UNITED STATES PATENT AND TRADEMARK OFFICE

APPLICATION NO.	FILING DATE	FIRST NAMED INVENTOR	ATTORNEY DOCKET NO.	CONFIRMATION NO.
10/791,842	03/04/2004	Juncheng Xu	3811-008-27	3856

DETAILED ACTION

FIG.4

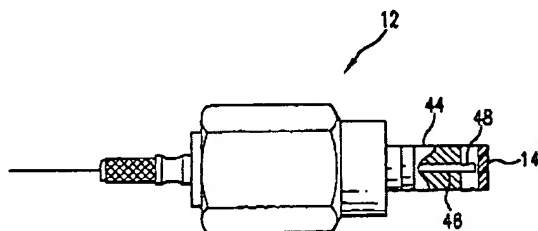
With regard to claim 1, Balachandran et al teach a sensor comprising:

a ferrule, the ferrule having a bore formed therein, the ferrule having a face, the face having a pit formed therein, the pit having a wider diameter than a diameter of the bore, the bore intersecting the pit(44);

a diaphragm attached to the ferrule such that it extends over the pit, the diaphragm having an inside reflecting surface facing the pit(14); and

a fiber disposed within the bore, an end of the optical fiber and the inside reflecting surface of the diaphragm being spaced apart to form a Fabry-Perot cavity(46).

attaching the fiber to the ferrule, an end of the optical fiber and the inside reflecting surface of the diaphragm being spaced apart to form a Fabry-Perot cavity(see figure 4; column 9, lines27-34).
